Town of Duanesburg
Zoning Board Minutes
May 17th, 2022
Final Copy

May 17, 2022RE: Public Hearing Oak Hill Solar Fence Variance

May 17, 2022 Biggs to Zoning Board Public Hearing Comments for Oak Hill Solar 1, LLC and Oak Hill Solar 2, LLC

RE: Public Hearing Oak Hill Solar Fence

PHOTO 1: LOOKING NORTHWEST FROM PROPERTY LINE

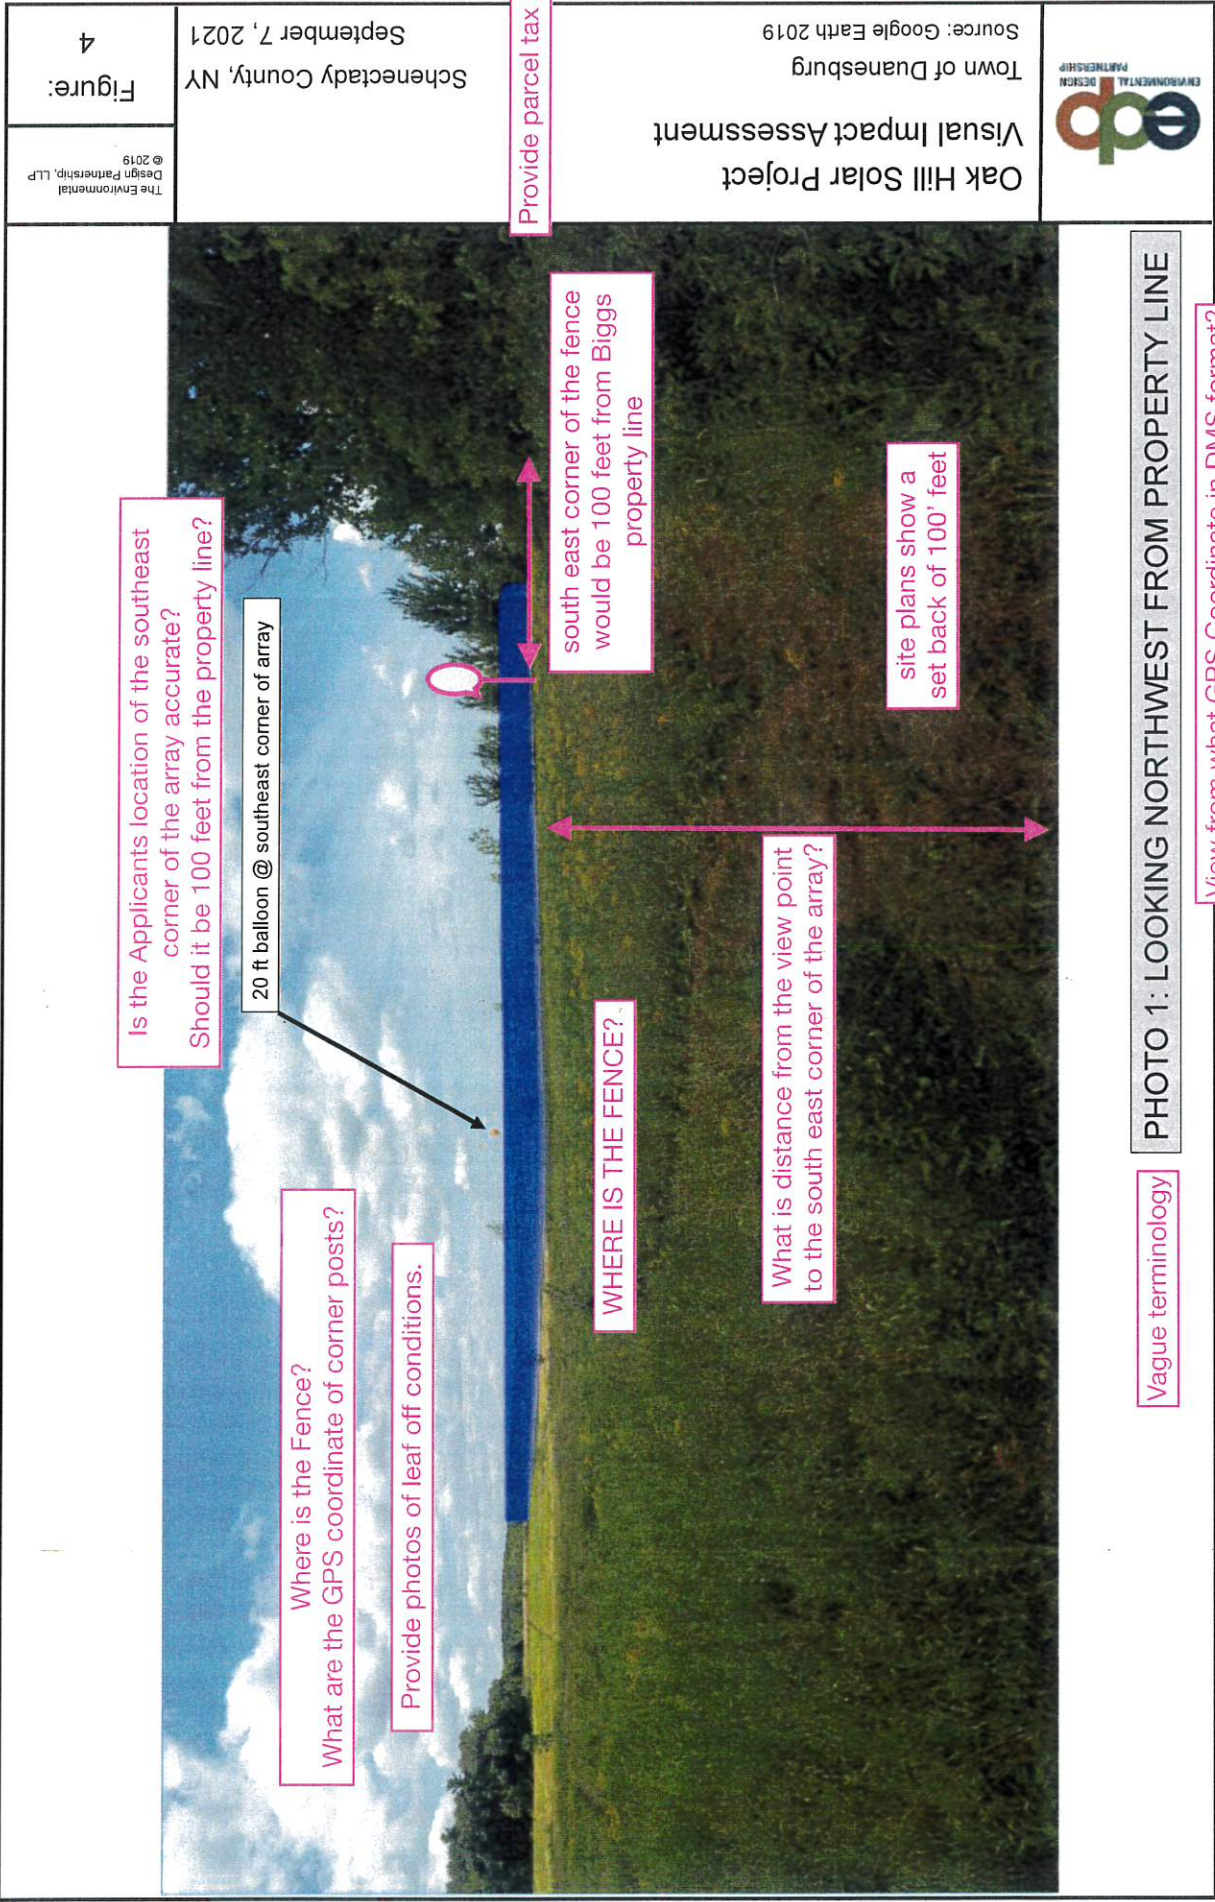
The Applicant considered one view point from the property line towards the array. It does not consider the abutters entire property line. The Project site does not provide any existing vegetative screening. Abutters were not consulted or informed about the "balloon test" The images are computer simulations. I invite the zoning board to walk my property line to gain a better understanding of the Project site and its impact on the community character, visual impact on abutters and potential of noise pollution.

View from what GPS Coordinate in DMS format?
To what GPS coordinate in DMS format?

Request the Applicant provide an in person meeting with
abutters and zoning board to conduct the balloon test.

PHOTO 2: LOOKING SOUTHEAST ACROSS PROPERTY LINE

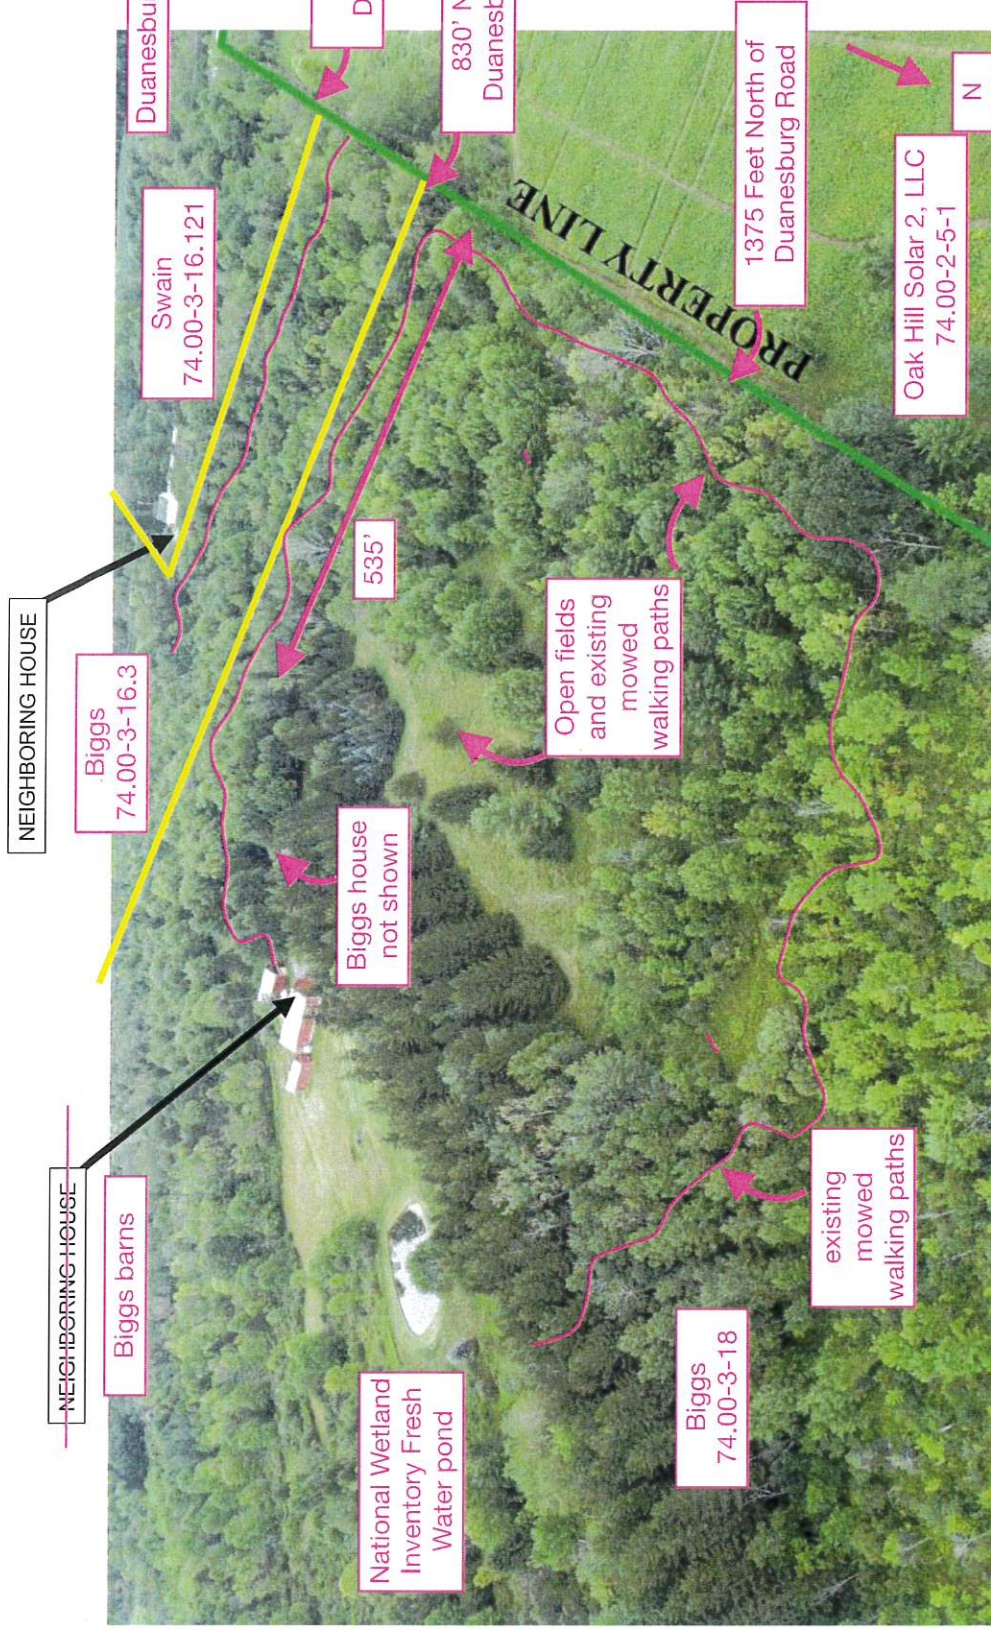
The Applicant misrepresents the Biggs house, parcels, existing open fields and mowed walking paths. The Applicant does not consider existing use of the entire parcel. It appears that the Applicant has misrepresented the abutting parcel to the zoning board. I request that the zoning board visit the Biggs properties for a full and accurate understanding of the Project fence, location, and acres on the abutters.

Figure:
6

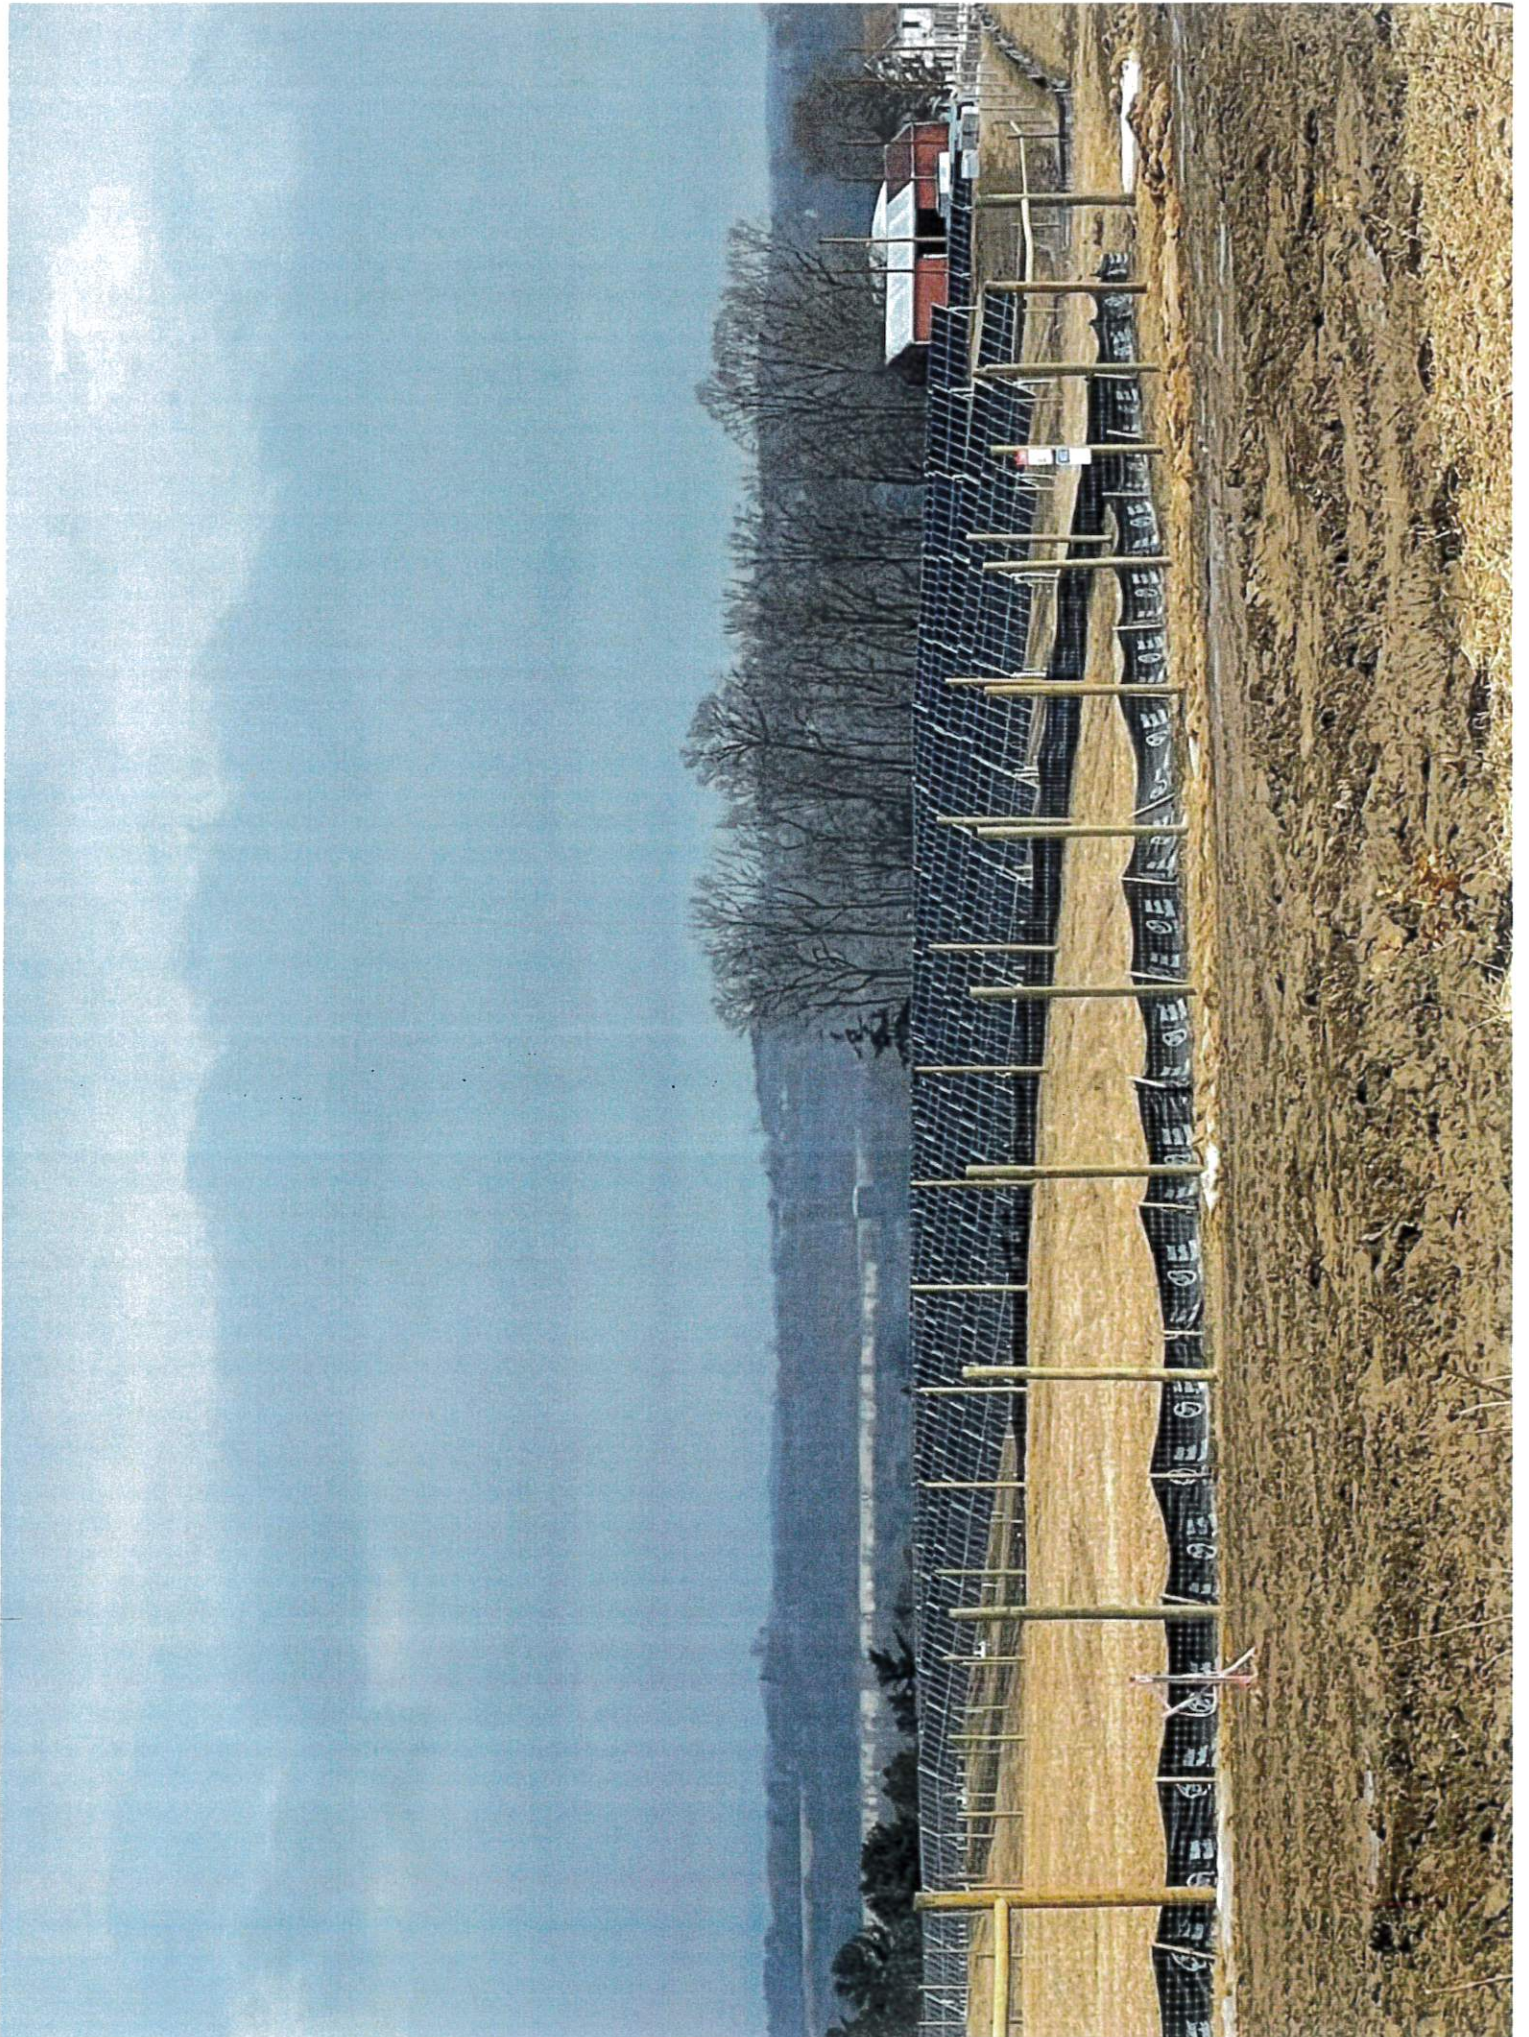
Applicant did not request access to Biggs lands to consider view to the solar facility and fence.
Leaf off conditions are six months out of the year. Please provide images of leaf off conditions.
Location of photos is not provided. Please provide GPS coordinates.
Figure 6 is random, vague and does not show the view from the abutters property to the solar facility and fence.

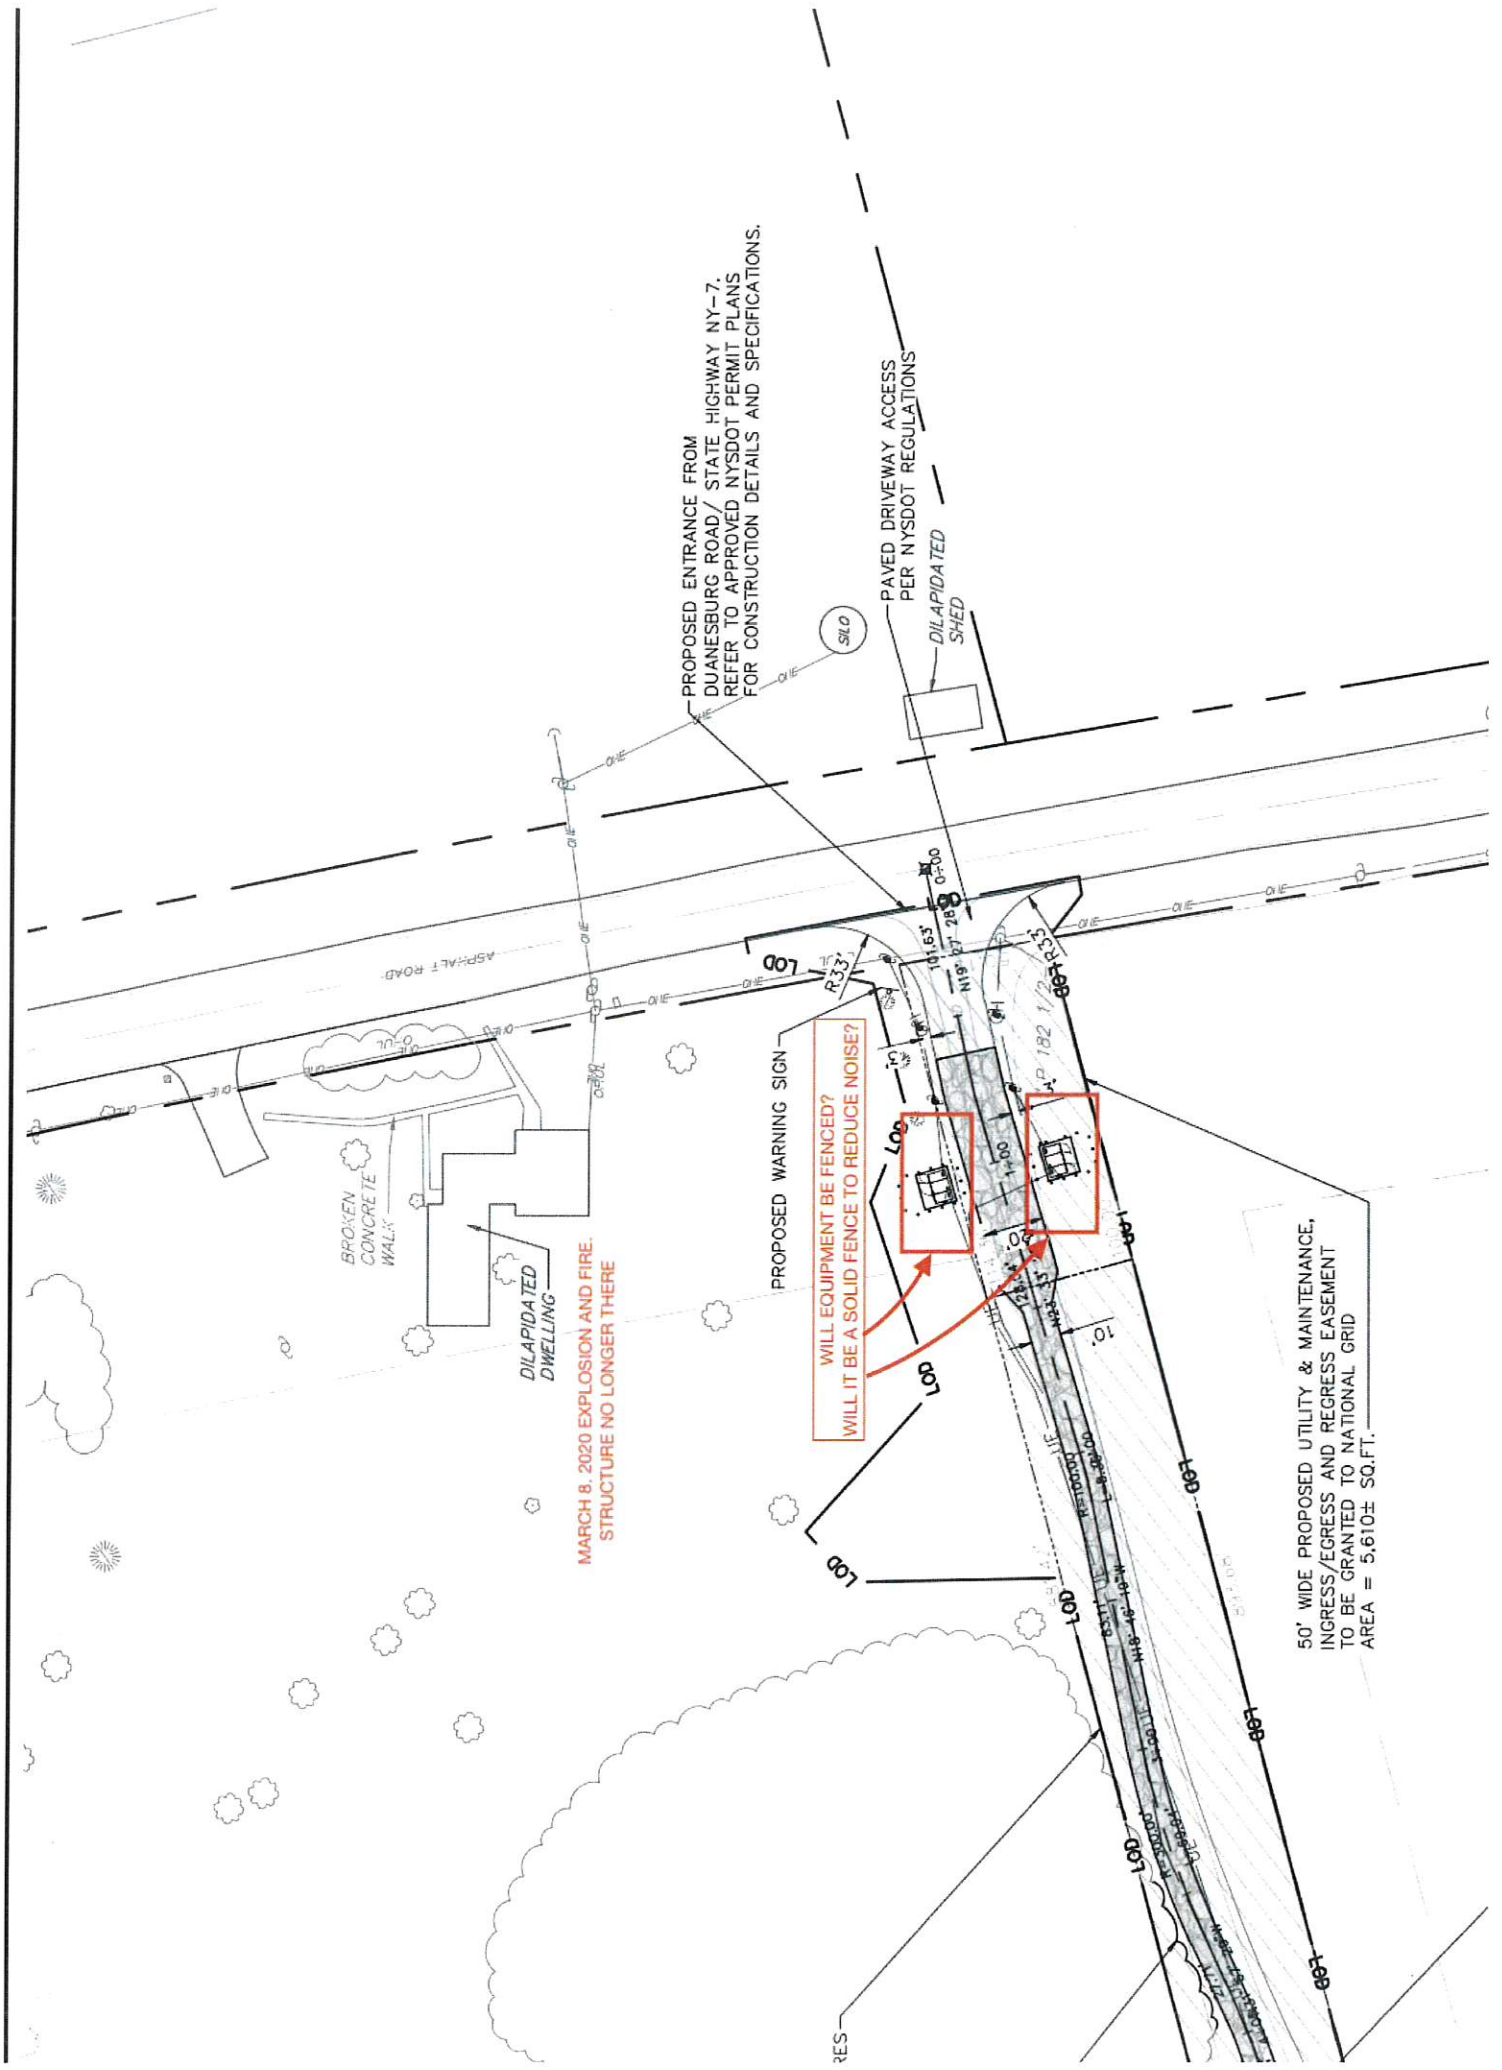
Thank you for considering the application of Oakhill Solar 1 and 2. The site plan shows two pieces of equipment located at the intersection of Duanesburg Road and the Project's Access Road. See attached Drawing C2.03. According to the Applicant's documents it appears that the two pieces of equipment are the major switchgear for each facility. The Applicant's February 7, 2022 Noise Analysis Chart indicates that the major switchgear is 100 dB at the source. See attached chart.

What is the purpose of the equipment?

What are the dimensions length x width x height of the equipment?

Is the equipment high voltage?

Is this equipment required by NEC code to be enclosed in a compliant fence?

WILL EQUIPMENT BE FENCED?
WILL IT BE A SOLID FENCE TO REDUCE NOISE?
